June 20, 2011  
U7-C-NINA-NRC-110080  
10 CFR 2.390

South Texas Project  
Units 3 and 4  
Docket Number PROJ0772  
Responses to Request for Additional Information

Reference: Request for Additional Information RE: South Texas Nuclear Operating Company  
Project Topical Report (TR) WCAP-17202-P, "Supplement 4 to Bison Topical Report  
RPA 90-90-P-A" (TAC No. RG0026) (ML111050109)

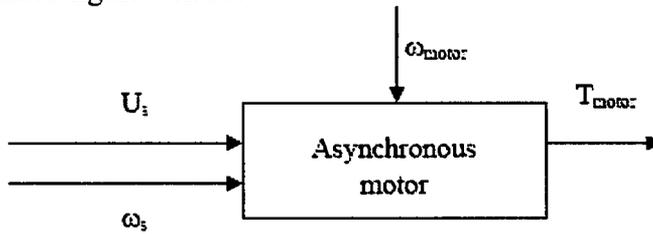
The BISON asynchronous pump model presented in Section 3.3.2.1 of WCAP-17202 includes a slip parameter  $k_s$ , defined as the relative difference between the stator and rotor angular speeds. Stator speed in this model is a time-dependent control input from SAFIR, while the rotor speed is described as a time-dependent output.

- a. Please clarify the procedure by which the slip parameter is calculated in BISON (e.g., using old timestep values of the angular speeds to calculate slip used in obtaining the new timestep rotor speed).
- b. Discuss how impedance  $Z_2$  was derived.

- a. The slip parameter definition in Equation 3-41 is not correctly described in the Topical Report.

In the BISON ASYNC model, the slip parameter is calculated in every time step according to the updated definition provided above. The terms " $\omega_s$ " and " $\omega_r$ " are both boundary conditions and when combined with the slip, and the generated power over  $R_2$  the angular momentum ( $T_{\text{motor}}$ ) can be found. The  $\omega_{\text{motor}}$  in Figure 3-15 is misplaced and hence the figure will be updated in the approved version of the topical.

The current figure is:

The updated figure will be:

The reason for this update is that equation 3-39 is not actually solved in the asynchronous motor model.
